## Water Leak at the Rear of the Moonroof

(Supersedes 08-015, dated May 13, 2008, to revise the information marked by the black bars)

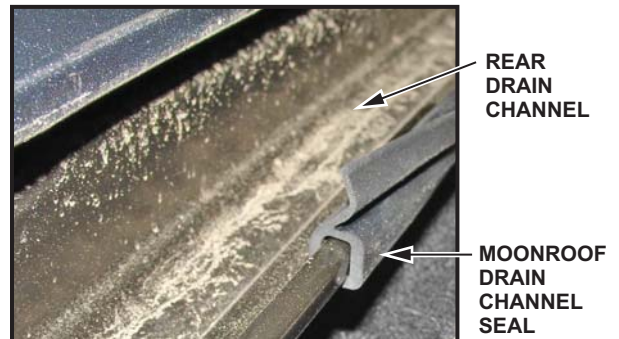
Water splashes out of the drain channel into the interior of the vehicle.

Install a moonroof drain channel seal.

1. Remove the moonroof glass to gain access to the rear drain channel:
  - Refer to page 20-65 of the *07–09 MDX Service Manual*, or page 20-63 of the *2010 MDX Service Manual*, or
  - Online, enter keywords **MOON GLASS**, and select **Moonroof Glass Replacement** from the list.
2. Install a new seal on the front edge of the rear drain channel:
  - Attach the lower lip of the seal starting at one corner of the drain.
  - Roll the seal up and rearward over the lip until it is installed all the way across the drain channel.
  - Make sure the seal is centered.
